COMMENTS & RESPONSES

25-35 Dolores Street Residential Project

PLANNING DEPARTMENT
CASE NO. 2006.0848E

Re: Attached Comments and Responses to Draft Environmental Impact Report
Case No. 2006.0848E: 25-35 Dolores Street

Partial Preservation Alternative – Elevation Figure 12

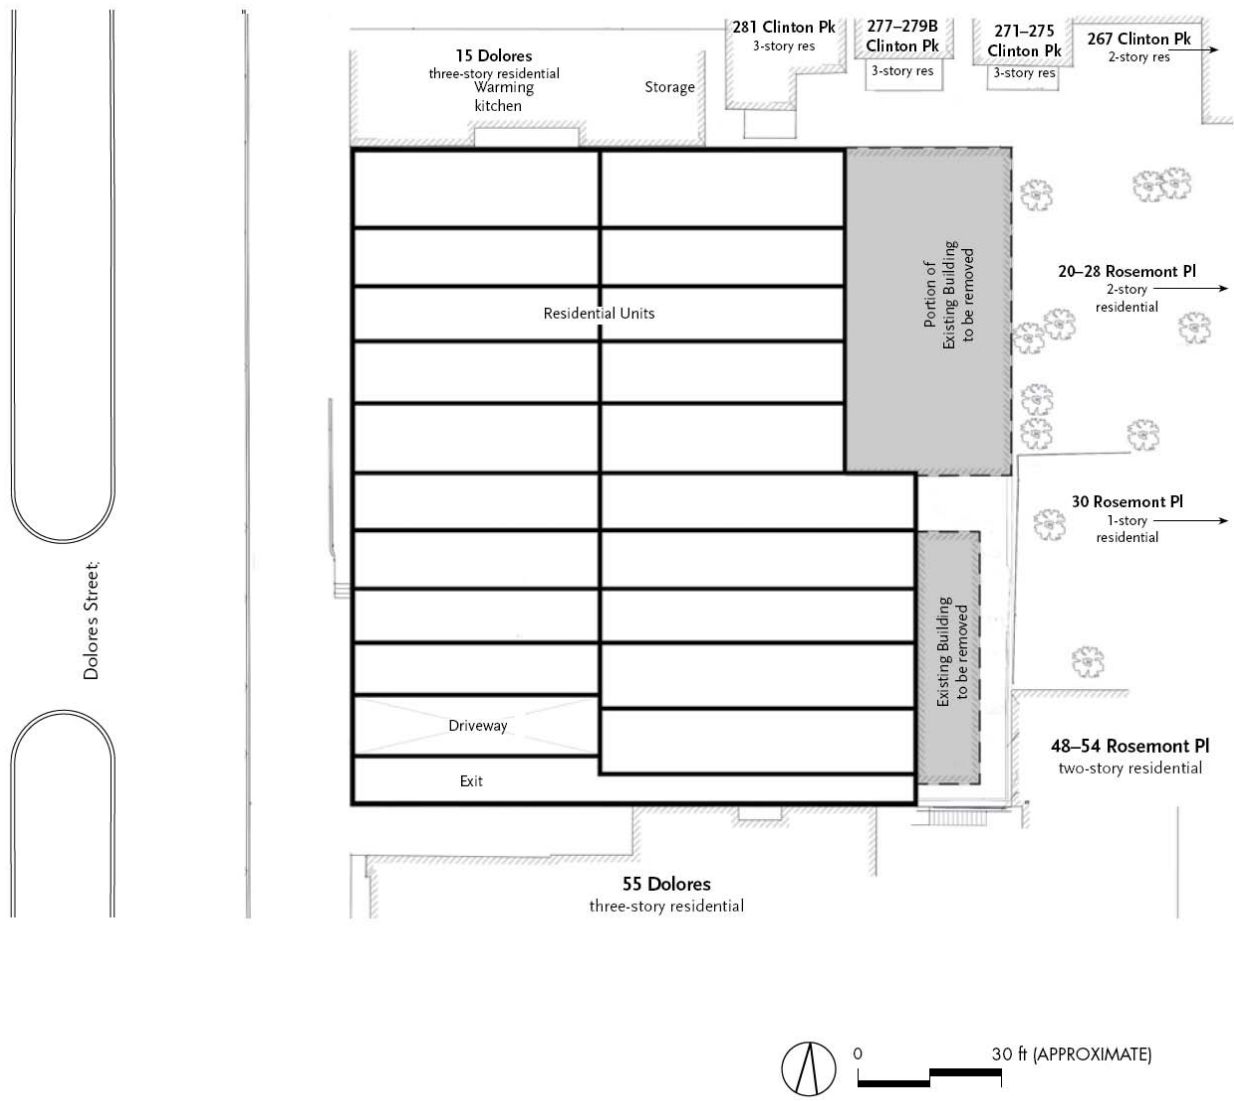
Page 62, Figure 12 of the DEIR, title is changed to:

Preservation Alternative—Schematic Site Plan Figure 10

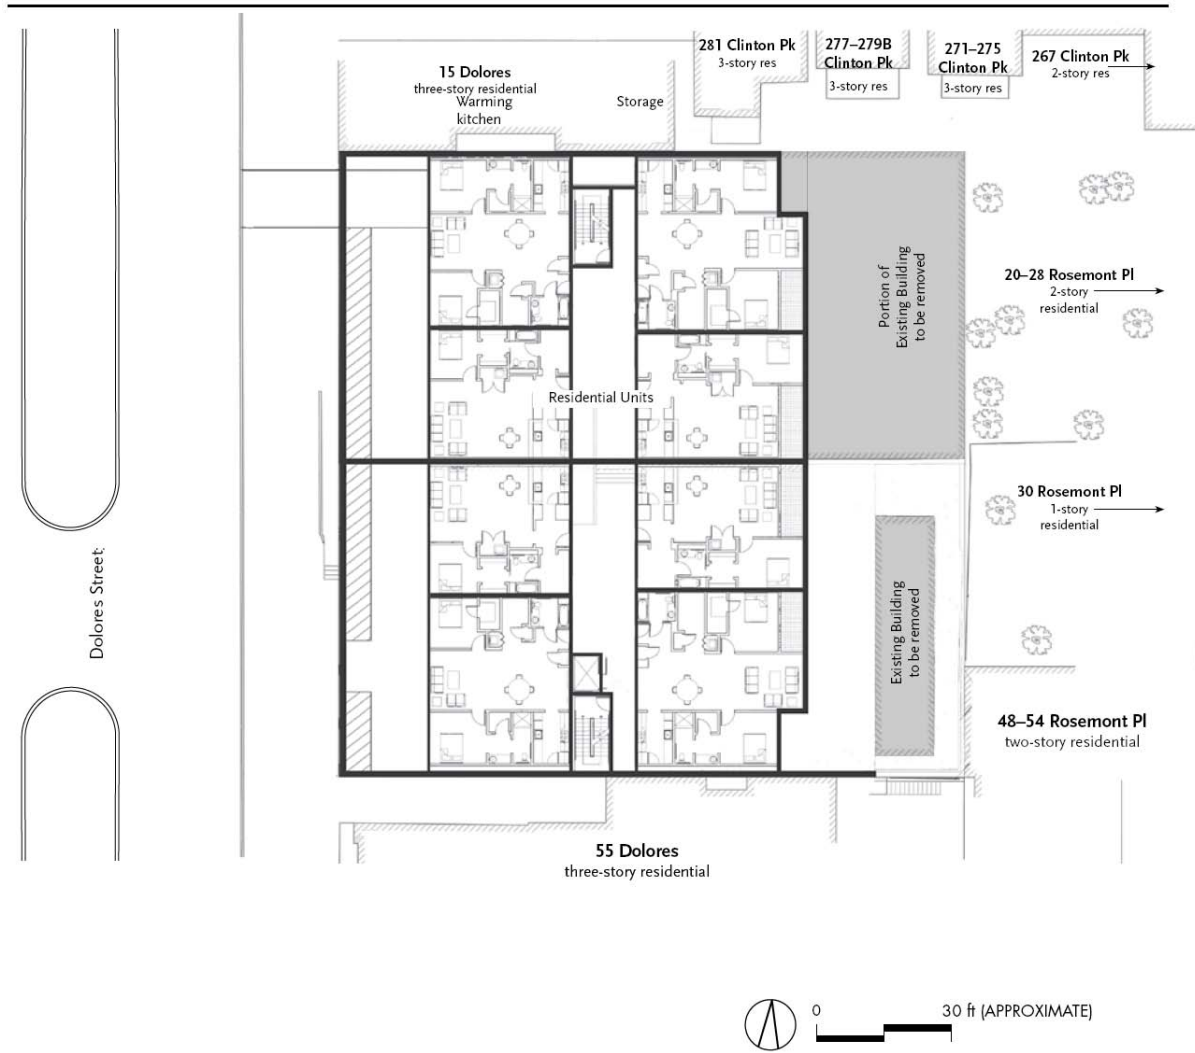
Figure 10, page 59a, illustrates the site plan of Alternative B.

Figure 10, page C&R. 62, is added to the DEIR on new page 59a.
